## **RADFORD ARMY AMMUNITION PLANT, VIRGINIA**

### **Work Plan Addendum 009: SWMU 31 and Horseshoe Area Groundwater Study**

Re: Radford Army Ammunition Plant  
SWMU 31 and the Horseshoe Area Groundwater Study  
Work Plan Addendum 9  
Document submittal and review

Response to EPA Comments on Master Work Plan (MWP) dated February 2002;  
Work Plan Addendum (WPA) 009, dated February 2002;  
And Work Plan Addendum (WPA) 012, dated February 2002  
Comments dated 22 May 2002  
From Rob Thomson

Figure 1-2  
Investigation Overview

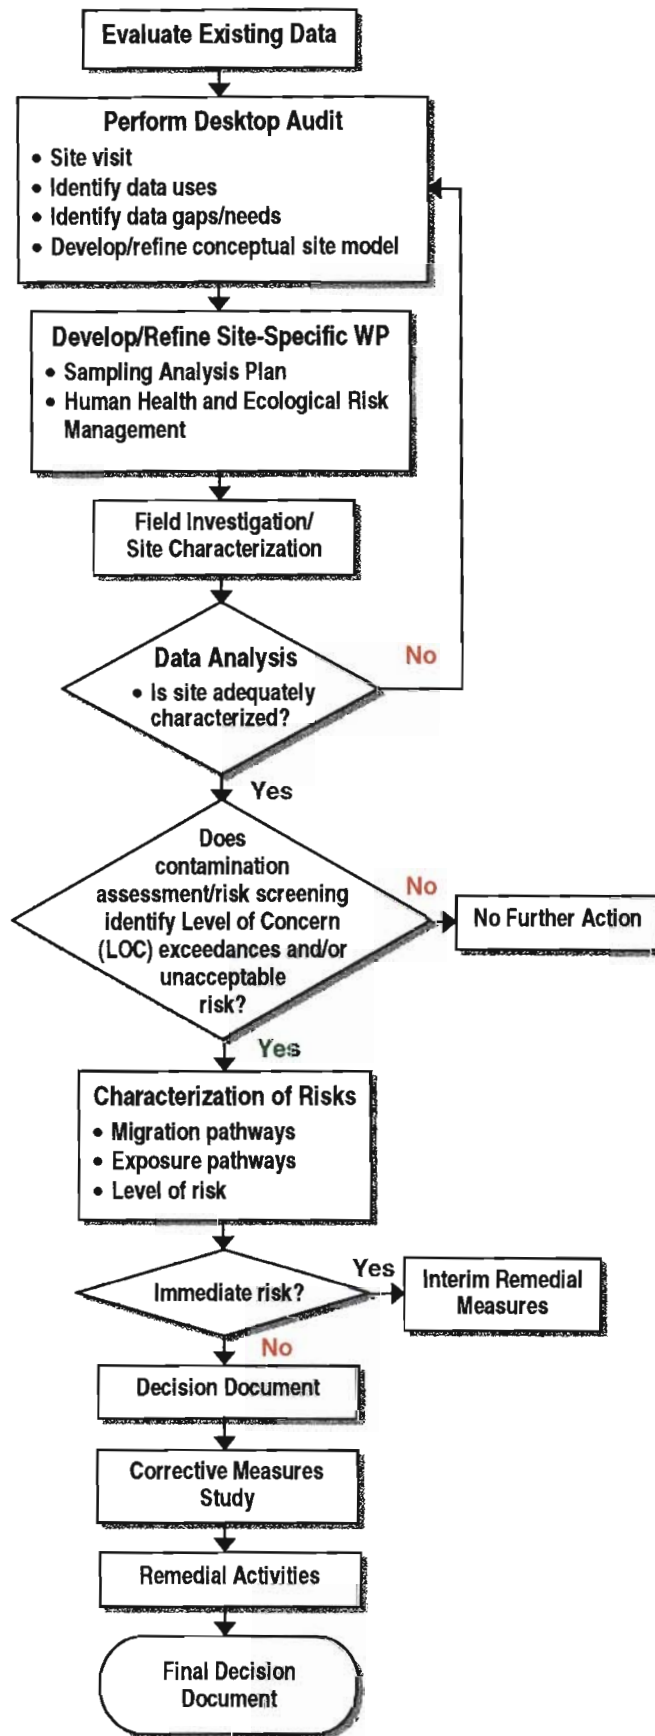
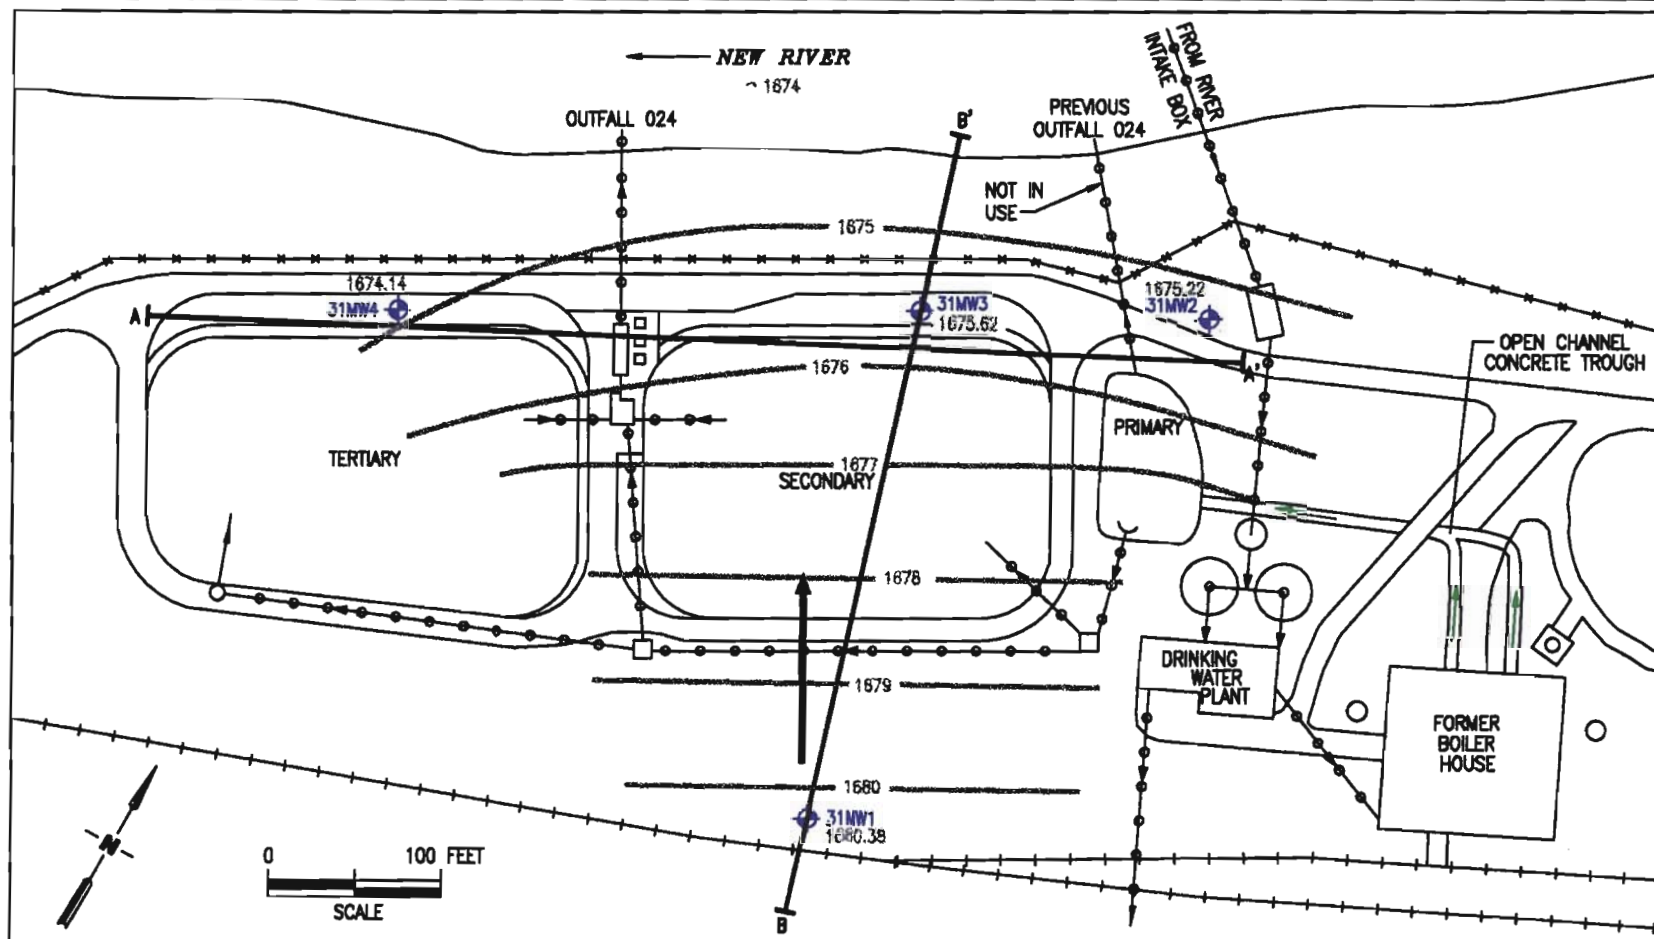
**Comment 1: Figure 1-2, Investigation Overview, Page 1-7**

1. **Figure 1-2, Investigation Overview, page 1-7:** The abbreviation "LOC" should be defined and added to the list of acronyms and abbreviations on page v.
2. **Section 1.2.2.3, RCRA Facility Investigation - Parsons, 1996, page 1-22:** This section indicates that it has not been verified whether the monitoring wells for SWMU 31 are upgradient or downgradient. However, Figure 1-6 refers to them as "downgradient" and "upgradient" wells. The

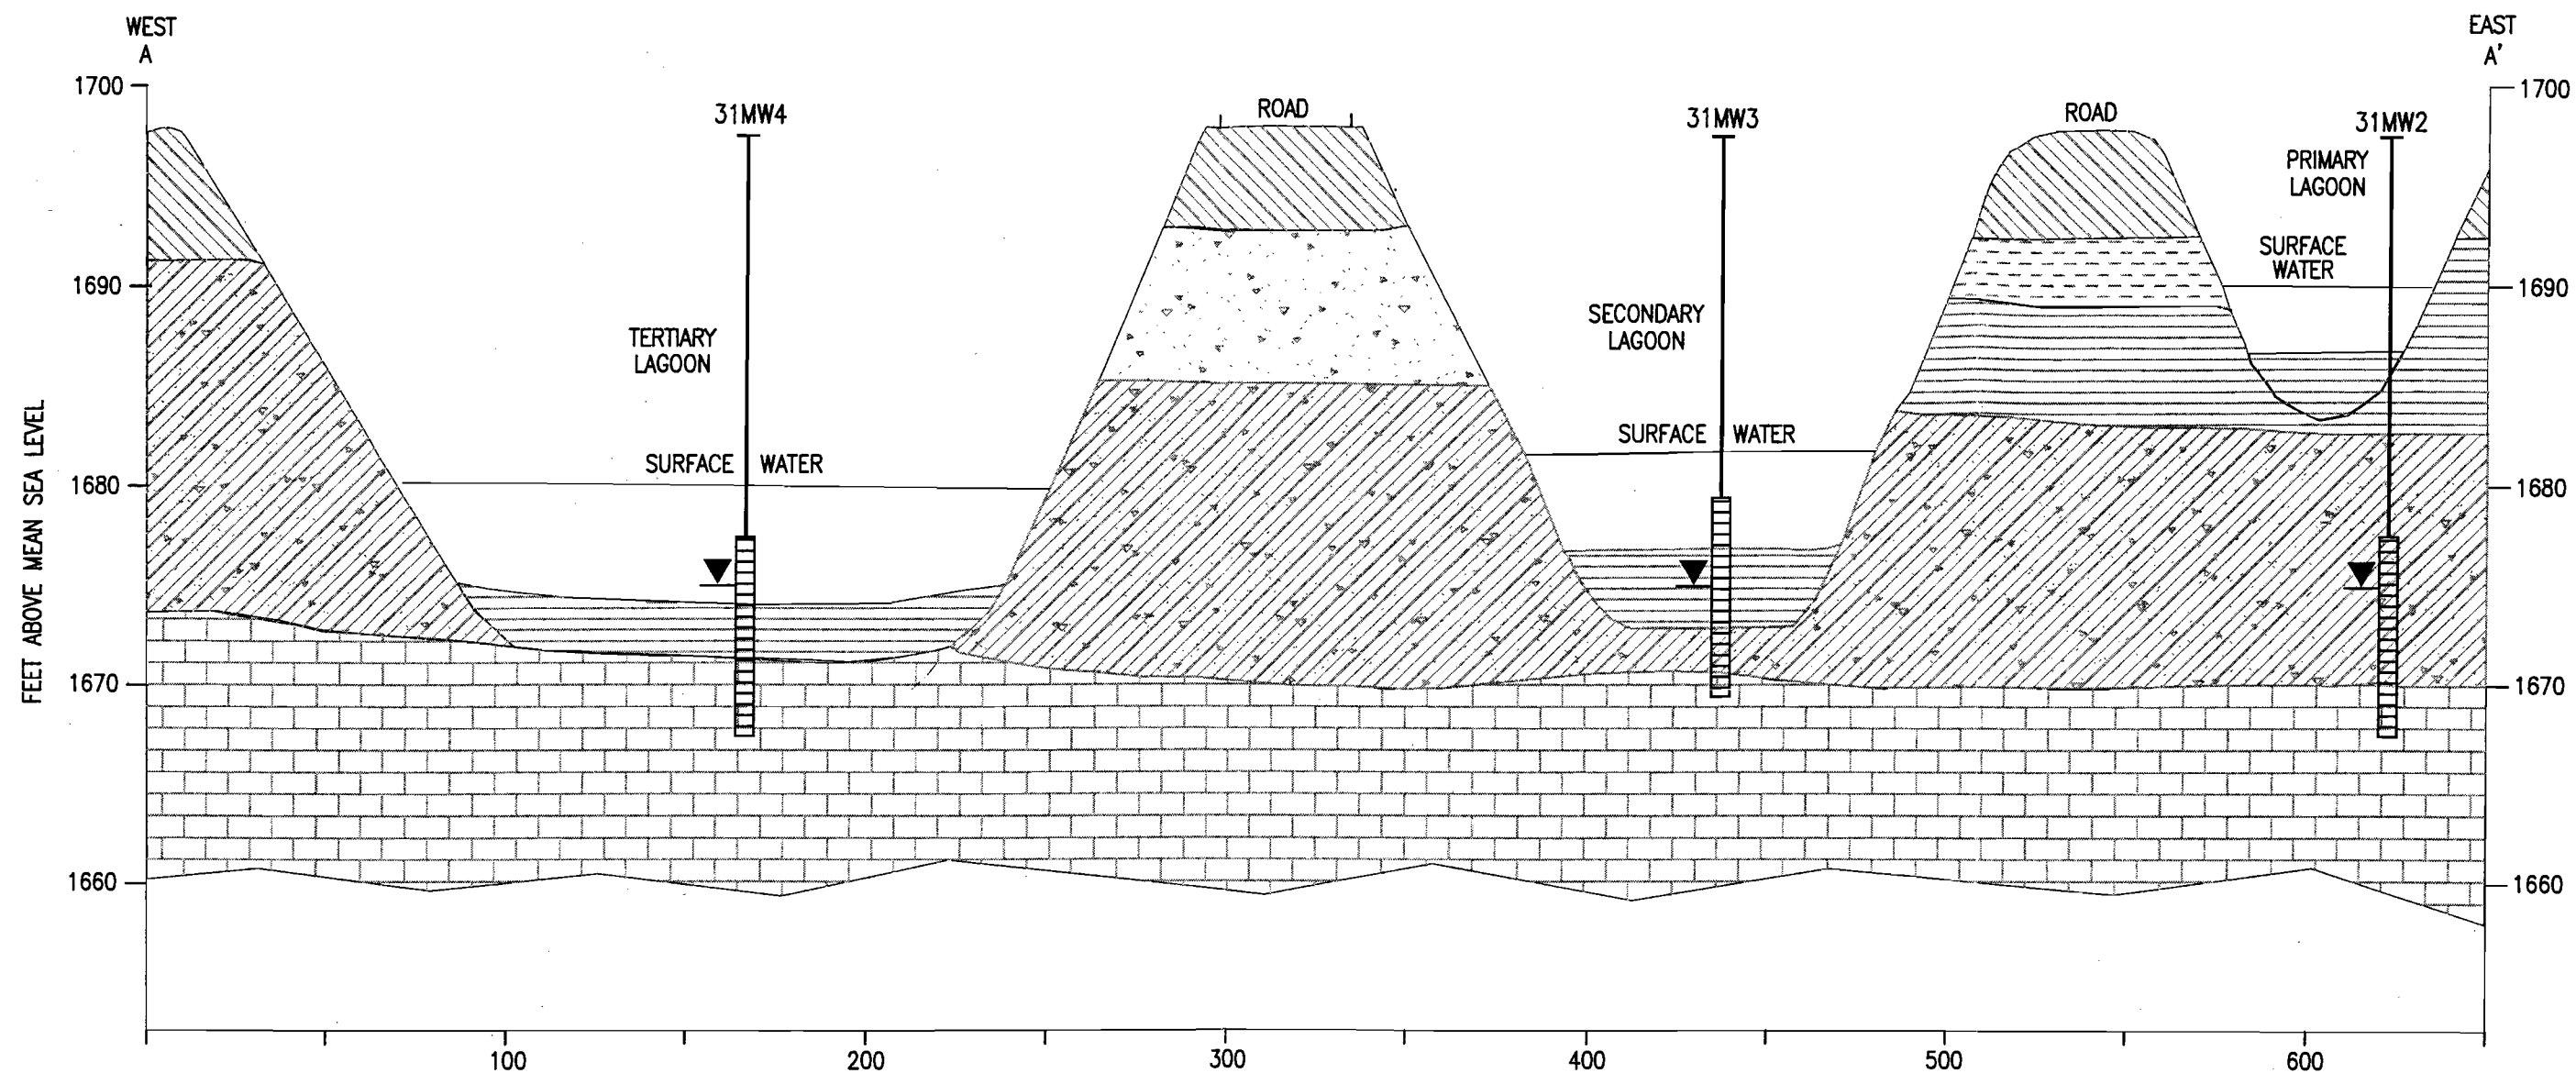
Figure 1-5 SWMU 31 Conceptual Model, indicates leachate possibly infiltrating the ground water, which flows to the New River. In the 1998 RCRA Facility Investigation, completed by ICF Kaiser, several constituents were detected in the lagoons sediment that exceeded residential, industrial RBC's and BTAG criteria. Recommendations in addendum 009 indicate that the collection of deep lagoon sediment, surface water and ground water samples be collected to supplement the current data. It may be advantageous to collect sediment samples, along the stretch of the New River where the lagoons lie, to verify if leachate is a concern.

4. Page 1-13, Figure 1-5, K. Fleischmann  
SWMU 31 Conceptual Site Model  
Comment: For clarification and completeness of the conceptual model, the flow direction of the New River should be provided.  
Recommendation: Add the flow direction of the New River to the figure.

**SWMU 31 GEOLOGIC  
CROSS SECTION (A-A')**

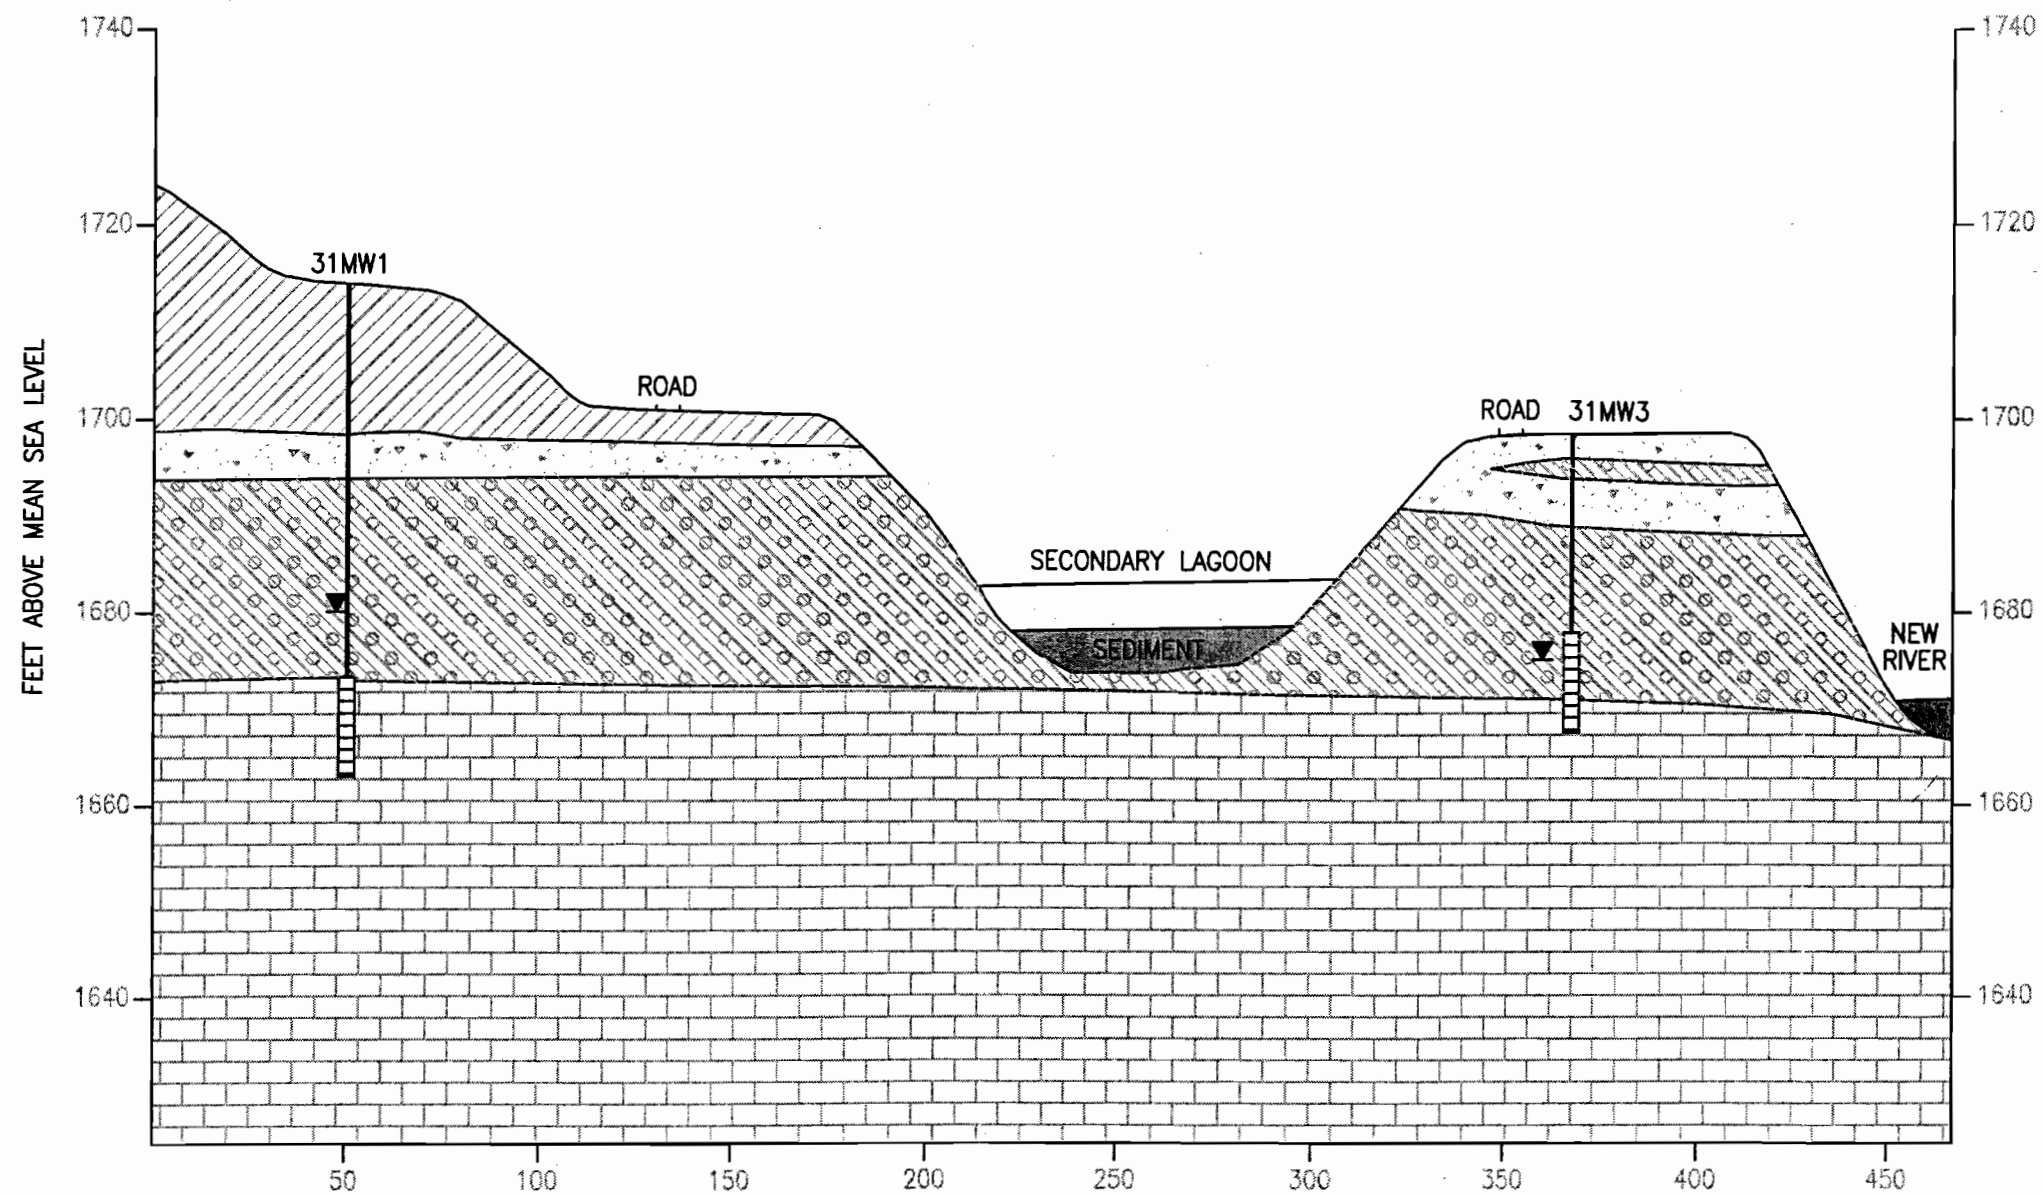
2. Page 1-9, Figure 1-3, K. Fleischmann  
SWMU 31 Geologic Cross Section (A-A')  
Comment: On the left side of the cross section, the symbol for the upper horizon is incorrect. The hachure lines are aligned opposite of the direction indicated in the legend.  
Recommendation: Change the direction of the hachure lines on the cross section to match the legend.

SWMU 31 GEOLOGIC  
CROSS SECTION (B-B')

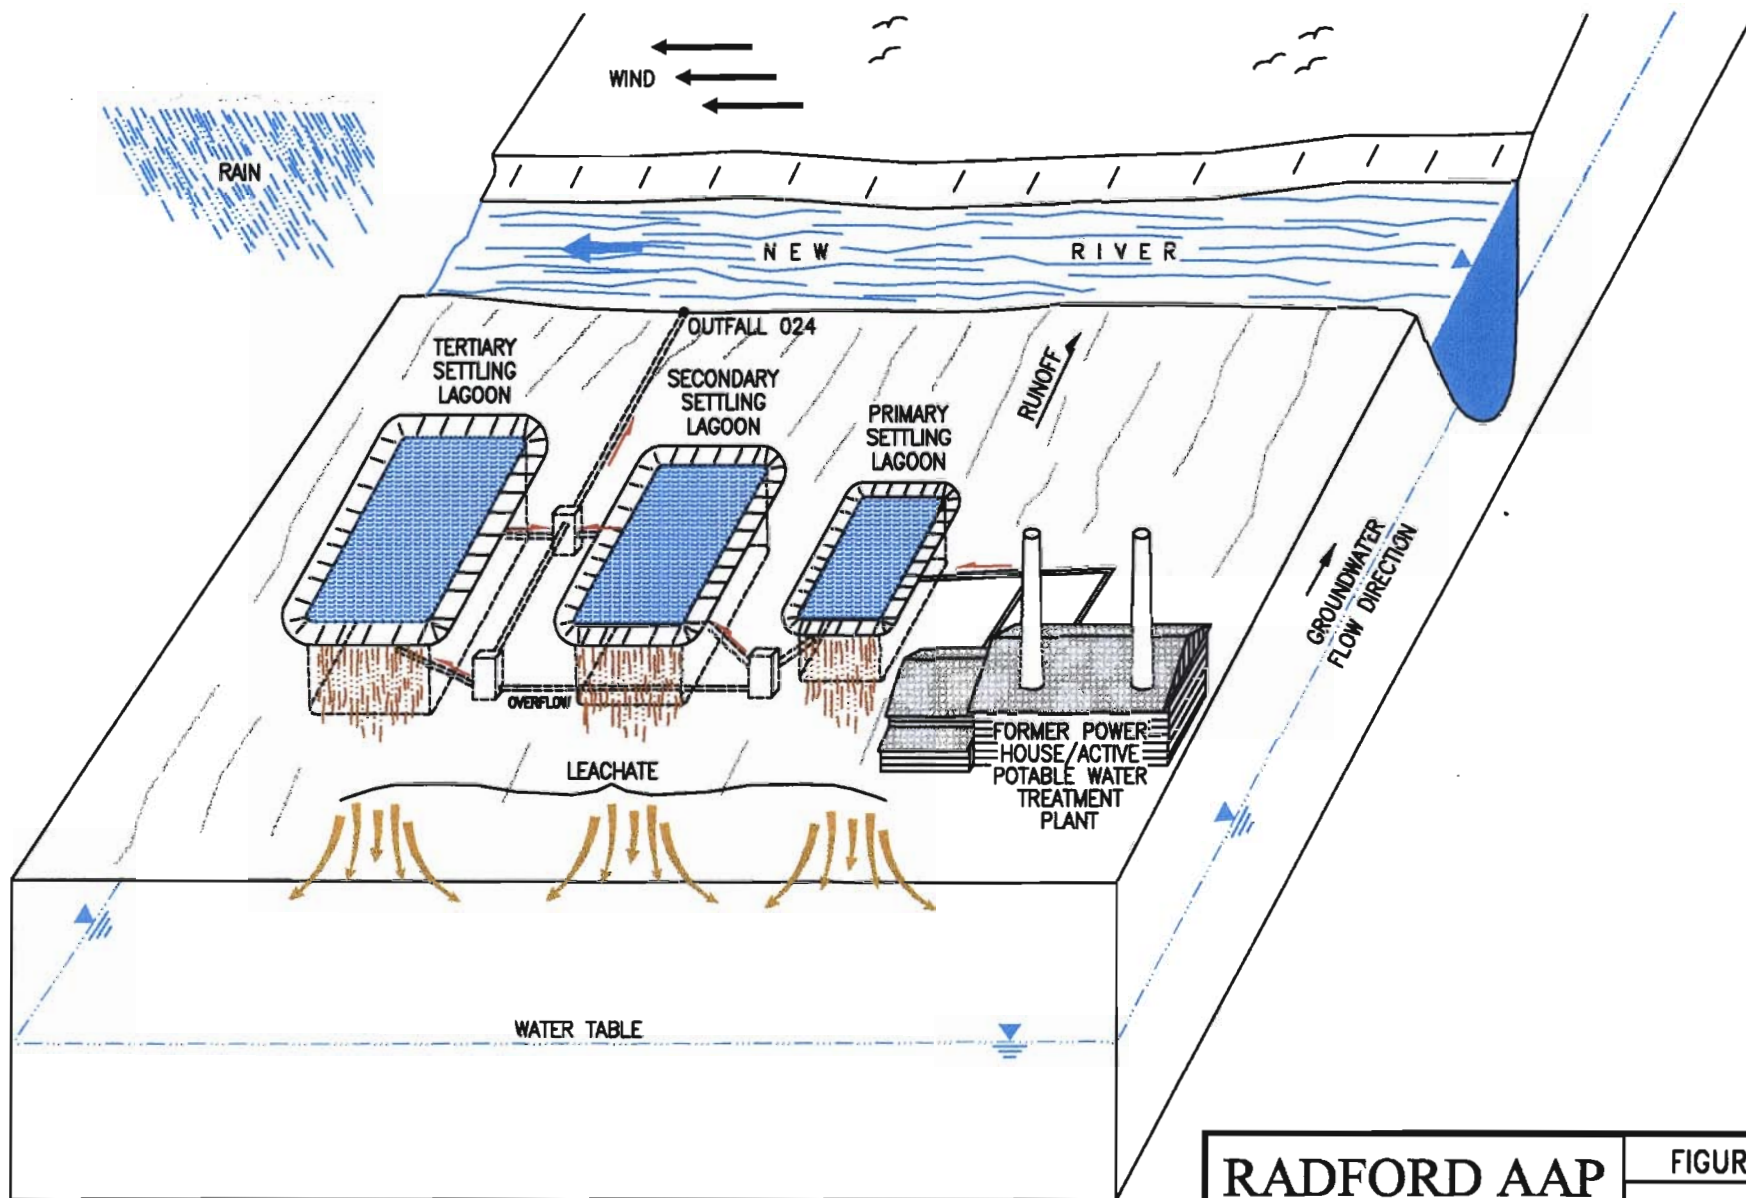
3. Page 1-11, Figure 1-4, K. Fleischmann  
SWMU 31 Geologic Cross Section (B-B')  
Comment: The symbol for "Gravel (GM/SM), Brown, Sand and Silt" is labeled incorrectly either on the cross section or on the legend. The hachure lines on the cross section are aligned opposite of the direction on the legend.  
Recommendation: Change the direction of the hachure lines on the cross section to match the legend.
